Project	IEEE 802.16 Broadband Wireless Access Working Group < http://ieee802.org/16 >	
Title	An ARQ with Cooperative Relays in IEEE 802.16j	
Date Submitted	2007-03-06	
Source(s)	Sunggeun Jin, Chulsik Yoon, Young-il Kim Electronics and Telecommunications Research Institute 161 Gajeong-dong, Yuseong- gu, Daejeon, 305-700, Korea	Voice: +82-42-860-1757 Fax: +82-42-861-1966 sgjin@etri.re.kr
Re:	This is a response to Call for Technical Proposals regarding IEEE Project P802.16j	
Abstract	The document contains technical proposals for IEEE P802.16j that would provide a n ARQ scheme by using multiple cooperative relays	
Purpose	The document is submitted for review by 802.16 Working Group members	
Notice	This document has been prepared to assist IEEE 802.16. It is offered as a basis for discussion and is not binding on the contributing individual(s) or organization(s). The material in this document is subject to change in form and content after further study. The contributor(s) reserve(s) the right to add, amend or withdraw material contained herein.

An ARQ with Cooperative Relays

Figure 1 Multiple-path-establishment for ARQ using cooperative relays

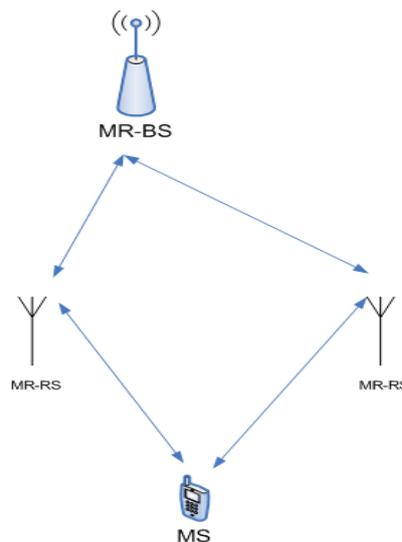
Fig.1 shows an example when an ARQ is utilized by supporting multiple paths when cooperative relays are deployed. In this figure, an MS transmits a frame both MRS simultaneously, and then, each MRS filters out erroneous frames by relaying successfully received frames toward MR-BS. In order to make it possible, MR-BS is required to configure each MRS to provide the ARQ scheme.

An MR-BS may establish multiple paths for single ARQ-enabled connection between itself and an MS via several MRSs. An MRS on each path shall drop incorrectly received frames with corrupt CRC. Otherwise, it shall forward the successfully received frames to the next destination on each path.
